| Intersection ID: 12618 | Main Street: E_5TH_ST | Cross Street: N_CALDWELL_ST | Location: | E |
| ADA ID: 0184F06BCA18 | Ramp Type: BlendTrans1 | Initial Pass/Fail: Pass | Overall Compliance: No | Severity Score: 20 |

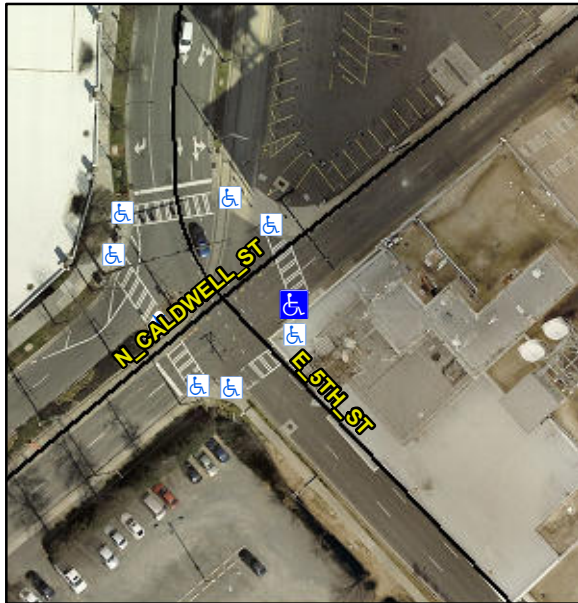
| Compliance | Description | Data | Compliance | Description | Data |
|-----------------|-----------------------|--------|------------|-----------------------------|--------|
| No | Ramp inside XWalk1? | No | N/A | Ramp inside XWalk2? | N/A |
| No | Any Obstructions? | Yes | Yes | Storm Grate/Utility Hazard? | No |
| POWER POLE 36.0 | | | | | N/A |
| | | | No | Curb Slope (%) | 10.8 |

**Remove & Replace Curb Slope and
Extend Ramp. Restripe Crosswalk.
Relocate Obstruction.**
